**APPENDIX A: GSP ASSESSMENT STAFF REPORT, SAN JOAQUIN VALLEY
– MERCED SUBBASIN (NO. 5-022.04)**

RE: Approved Determination of the Revised Groundwater Sustainability Plan Submitted for the San Joaquin Valley – Merced Subbasin

**STATEMENT OF FINDINGS REGARDING THE
APPROVAL OF THE
SAN JOAQUIN VALLEY – MERCED SUBBASIN
GROUNDWATER SUSTAINABILITY PLAN**

State of California
Department of Water Resources
Sustainable Groundwater Management Program
Groundwater Sustainability Plan Assessment
Staff Report

Figure 2: Subsidence Monitoring Network¹⁴⁹

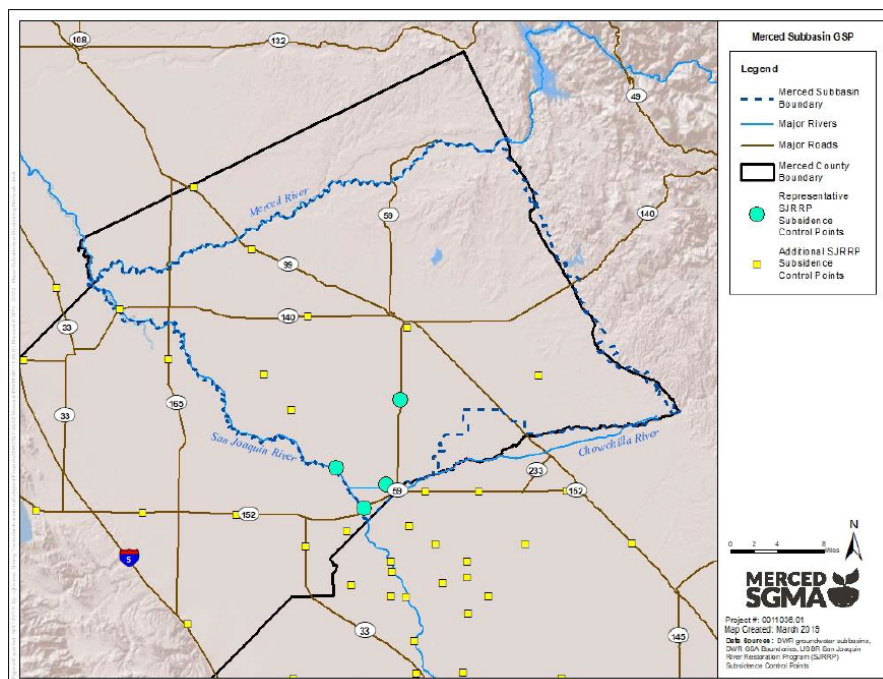
groundwater levels and the subsidence monitoring network, Department staff are concerned the GSAs will not be able to monitor subsidence adequately. Figure 2 shows the representative sites used by the Agencies to monitor for subsidence within the Subbasin. Figure 3 shows the water levels monitoring network and the data gap areas, including the wells which are monitoring Above Corcoran Clay layer and Below Corcoran Clay layer. The GSP states that there is a data gap along the western edge of the Subbasin and that installing wells along this area would help improve the understanding of subsurface groundwater flow between adjacent subbasins, depletions of interconnected surface waters, subsidence, and connection between principal aquifers. The GSP also states that there are plans to add wells for the Above and Below Corcoran Principal Aquifers in the southwesterly portion of the Subbasin and wells in the northwestern portion of the Subbasin.¹⁴⁸ While the GSP states data gap areas #2 and #3 and a plan to fill these data gaps will be submitted within two years of Plan approval, Department staff believe efforts on filling these data gaps are crucial for the Subbasin’s management of subsidence with the presence of the Corcoran Clay and the GSAs’ intentions to operate the basin below historical lows. It’s unclear to Department staff how the implementation of the Above Corcoran Sustainable Management Criteria Adjustment Consideration Management Action will be able to accomplish its goal given the data gaps. Department staff recommend the GSAs prioritize filling these data gaps and describing how filling these data gaps will assist in the successful implementation of the Above Corcoran Sustainable Management Criteria Adjustment Consideration Management Action. (See [Recommended Corrective Action 8](#))
